# UNITED STATES PATENT AND TRADEMARK OFFICE

10/597,158

<b>Office Action Summary</b>	<b>Application No.</b> 10/597,158	<b>Applicant(s)</b> WAGENER ET AL.	
	<b>Examiner</b> JEFFREY ALLEN	<b>Art Unit</b> 3781

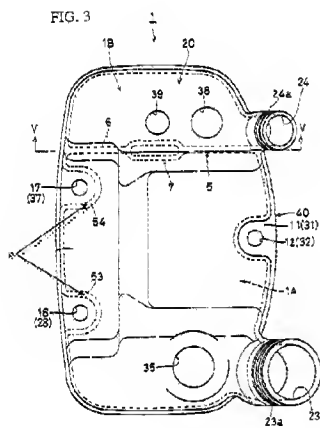
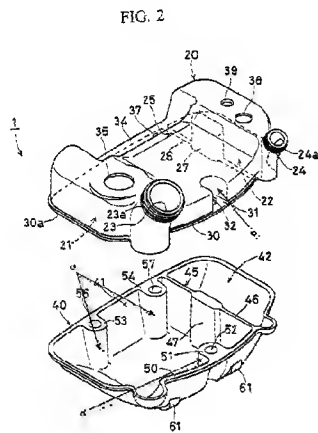
10. Regarding claims 1-6 and 8, Yokochi discloses a tank for oils or liquids comprising a tank part (1) having a tank volume, a fastening means (81) made up of a screw connections that pass through the tank volume in a leak proof manner, ducts (d, Fig. 2 below labeled by examiner) extending within the tank part on an outer circumference of the tank part that screws extend through, a tank cover (col. 4, lines 16-18), a filler neck (23) and two connection pipes (73 and 76). The ducts are shortened in relation to the depth of the tank and recesses are provided on the circumference of the tank, this creating a space between the ducts and the tank cover (Fig. 4). The screws are premounted on the tank prior to use and the tank further providing positioning aides (p) located on an outer surface of the tank part in an area of first and second ducts.

11. Regarding claims 9-12, 14, 17, 18 and 20, Yokochi discloses all the claimed limitations as shown above and a tank base (40) and tank cover (20).

12. Regarding claims 15 and 16, Yokochi discloses all the claimed limitations as shown above and a means for actuating on an actuating side opposite the side of the fastener used for fastening.
